Contract #: 04-0120F4Cty: SF/ALA Rte: 80 PM: 13.2/13.9File #: 69.25B**QUALITY ASSURANCE -- NON-CONFORMANCE REPORT****Location:** Changxing Island, Shanghai, China**Report No:** NCR-001001**Prime Contractor:** American Bridge/Fluor Enterprises, a JV**Date:** 24-Apr-2011**Submitting Contractor:** Zhenhua Port Machinery Company, Ltd (ZPMC), Changxing Island**NCR #:** ZPMC-0959**Type of problem:**

Reference Description: Missed UT Indication Discovered by QA on an Channel Splice Plate that is not able to be identified

To:	AMERICAN BRIDGE/FLUOR, A JV 375 BURMA ROAD OAKLAND CA 95607	Date:	26-Apr-2011
Dear:	Mr. Charles Kanapicki	Contract No:	04-0120F4 04-SF-80-13.2 / 13.9
Attention:	Mr. Thomas Nilsson Project/Fabrication Manager	Job Name:	SAS Superstructure
Subject:	NCR No. ZPMC-0959	Document No:	05.03.06-000958

Dated: 04-May-2011
Contract No.: 04-0120F4
04-SF-80-13.2 / 13.9
Job Name: SAS Superstructure
Document No.: ABF-NPR-000949 Rev: 00

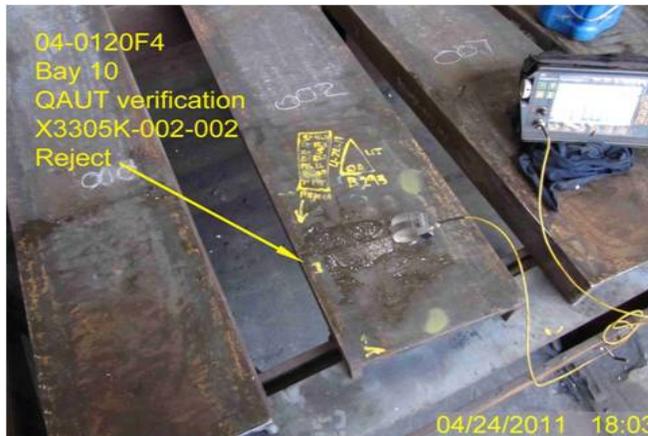
During the Quality Assurance Ultrasonic Testing (UT) verification of weld located on X3305K-002-002 weld, this Quality Assurance Inspector (QA) discovered the following issues:

- One (1) Class "A" indication measuring approximately 10mm in length.
- The Indication rating is +9dB.
- Piece Mark "X3305K" was not able to identified per the latest shop drawing.
- The thickness of the plate is 18mm and depth of the indication approximately 15.8mm.
- The "Y" location is approximately 195mm from weld termination.
- The weld is a Complete Joint Penetration (CJP) Corner-Joint joining flange to the web.
- The indication is clearly marked by CT QA on/near the weld.
- Fabricated channel assembly is located inside Bay 10.

The Notice of Witness Inspection Number (NWIT) is 08919, Item 3. The indication is located within the area that has been previously tested and accepted by ZPMC Quality Control (QC) personnel. As per the contract documents, ZPMC's QC personnel are required to perform 100% UT inspection of this weld.

AWS D1.5-2002, Section 6, Table 6.3; "Specifies a class A indication in this category shall be rejected (regardless of length).

This proposed resolution is acceptable. The documentation received is sufficient and the Department concurs that Non-Conformance ZPMC-0959 is closed.

ZPMC acknowledged this problem and has issued an internal NCR. ZPMC has repaired the indications noted in the NCR and is providing WR & NDT documentation after the repair to show the indication has been removed. Based on these actions, ZPMC requests closure of this NCR.

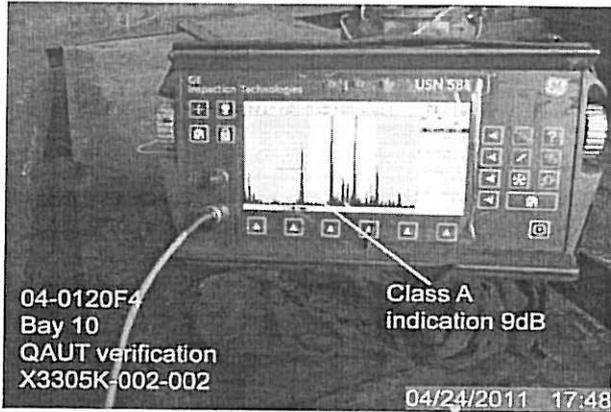
During the Quality Assurance Ultrasonic Testing (UT) verification of weld located on X3305K-002-002 weld, this Quality Assurance Inspector (QA) discovered the following issues:

- One (1) Class "A" indication measuring approximately 10mm in length.
- The Indication rating is +9dB.
- Piece Mark "X3305K" was not able to identified per the latest shop drawing.
- The thickness of the plate is 18mm and depth of the indication approximately 15.8mm.
- The "Y" location is approximately 195mm from weld termination.
- The weld is a Complete Joint Penetration (CJP) Corner-Joint joining flange to the web.
- The indication is clearly marked by CT QA on/near the weld.
- Fabricated channel assembly is located inside Bay 10.

The Notice of Witness Inspection Number (NWIT) is 08919, Item 3. The indication is located within the area that has been previously tested and accepted by ZPMC Quality Control (QC) personnel. As per the contract documents, ZPMC's QC personnel are required to perform 100% UT inspection of this weld.

AWS D1.5-2002, Section 6, Table 6.3; "Specifies a class A indication in this category shall be rejected (regardless of length).

Contractor will repair the weld indication. Contractor will provide the NDT report to prove the weld is acceptable after repair.

Contractor repaired the weld and submitted the NDT report showing the weld is sound. ZPMC issued an internal NCR to the personnel concerned.

项目名称 Project Name	美国海湾大桥 SFOBB	部件图号 Drawing No	X3305K-002	报告编号 Report No.	B-WR20827
合同号 Contract No.	04-0120F4	部件名称 Items Name	CONNECTION PLATE	NDT报告编号 Report No. of NDT	B787-UT-20533R
项目编号 Project No.:	ZP06-787		OUTSIDE

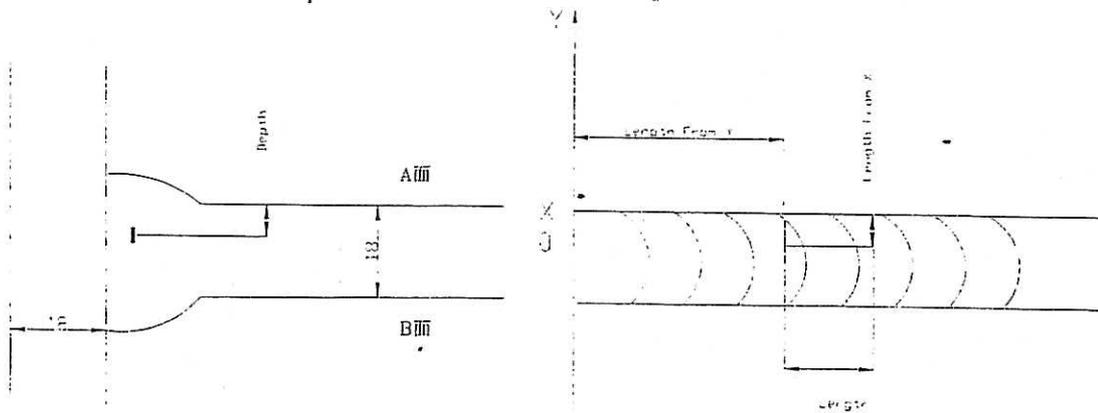
(Description of welding discontinuity): Rejected indication found by ultrasonic inspection is less than the maximum allowance aggregate length.

焊缝编号为 x3305k-002-002

- 1、焊道未及时处理干净。
1. Did not clear the weld pass completely in time.

1. 从缺陷距离端面较近一侧 ($D \leq 0.65T$, D 为缺陷深度, T 为板厚) 采用碳刨或打磨的方法去除焊缝缺陷;
 2. 参照返修焊接工艺规程 (WPS) 准备正确的接头型式, 预热和焊接;
 3. 将修补区域打磨到与母材或邻近焊缝平齐;
 4. 根据批准的车间图纸检查焊缝.
-
1. Gouge or grind from nearer side from metal edge ($D \leq 0.65T$, "D" is depth of defects, "T" is thickness of metal) to remove all defects;
 2. Follow repair WPS for joint preparation, preheat, and weld deposit;
 3. Grind the repaired area flush with base metal or the adjacent weld;
 4. Check the welds according to the working drawings.
